**TRANS MOUNTAIN PIPELINE ULC (TRANS MOUNTAIN)  
TRANS MOUNTAIN EXPANSION PROJECT (Project, TMEP)**

**Application pursuant to subsection 69(1) of the Canadian Energy Regulator Act Mountain 3 Horizontal Directional  
Drill Variance Application**

**Mountain 3 HDD – Request for Variance**

**NOTICE OF MOTION**

Figure 1. TMEP DCN-01094 signed on November 27<sup>th</sup>, 2023 indicating reasons for deviating from their own procedures.

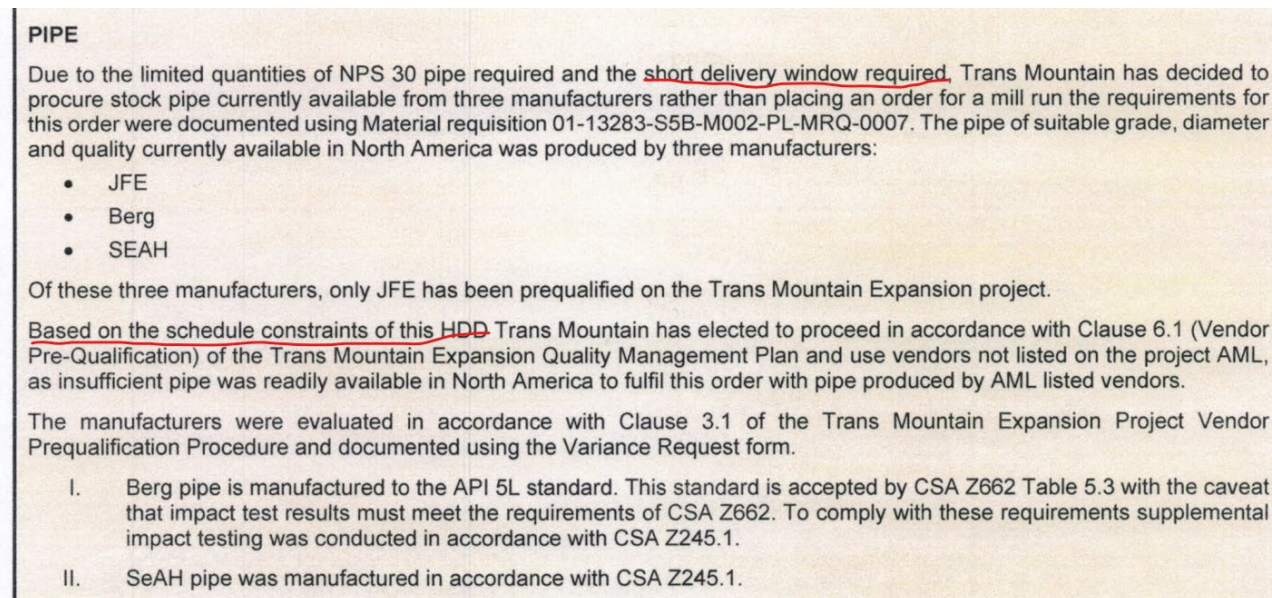
Below is evidence, from TMEP documentation ([C27483-1](#), page 13) that deviation are being made based on short delivery window and schedule constraints.

TMEP responded with a signed DCN (Design Change Notice) signed on November 27<sup>th</sup>, 2023, the day of the oral hearing! ([C27483-1](#), page 13).

From TMEP responses, there is no evidence that this process was applied.

Figure 3: Fraser River feasibility report showing risks related to HDD length and diameter.

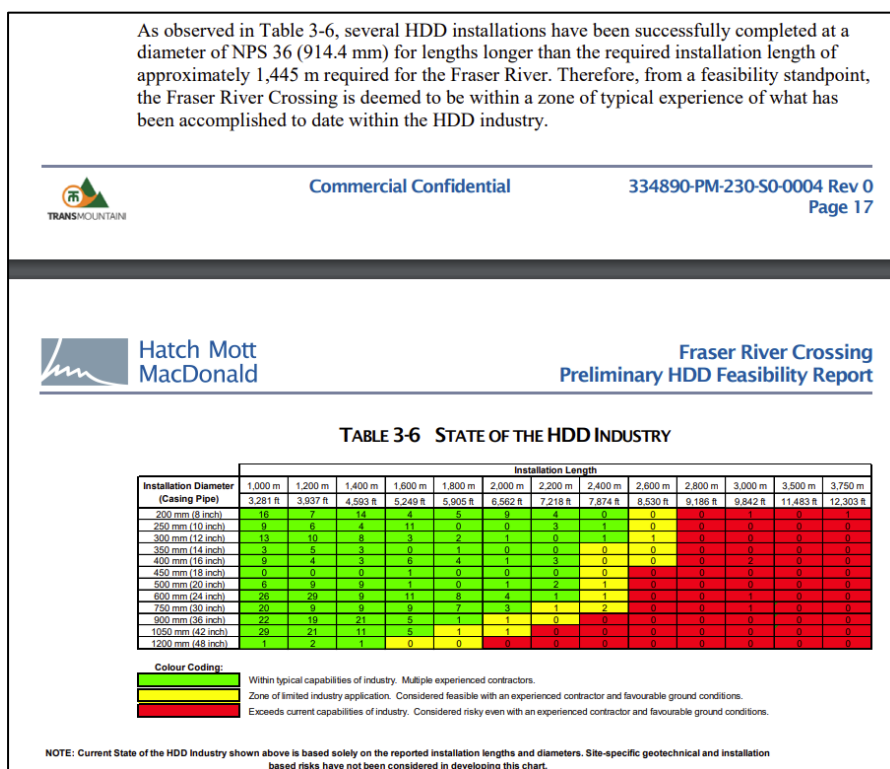
All these reports were made for a NPS 36 1,445m HDD crossing. In the Hatch assessment, it shows the level of risk for such crossing ([B324-11](#), pdf page 22 of 101):

The Mountain 3 is a 2,400m crossing over a hard rock, vs. the 1,445m crossing of soft soil of the Fraser River (which posed other risks).

Here is a comparative assessment of the North Fraser with the Mountain 3 crossing, using the same State of HDD Industry table from the Hatch feasibility report mentioned above:

- Fraser River Crossing: 36-inch, 1,400m – falls on green area, “within capabilities of industry”
- Mountain 3 Crossing: 36-inch, 2,400m – red area “exceeds current capabilities of the industry”

Notice that, even by changing the pipeline to NPS 30, it still lands in the yellow area, ie. it is considered feasible with an experienced contractor and “favorable ground conditions”, which is not the current case, as we are dealing with hard rock.
